GRA Comments on GBC's Draft Tall Buildings SPD

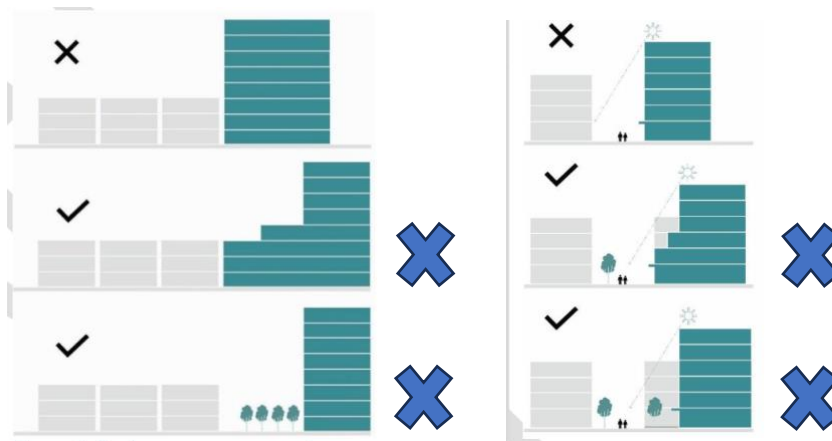
Figure 4 is overly simplistic, could mislead and should be amended. A gap or stepping where the tall building abuts other development might be ok but moving the building line to the boundary with no set back or stepping on the other side, which may be a road, river or narrow street, may not merit a “tick” in a Guildford context. Hence the diagram is inappropriate. Figure 9 has a similar issue.
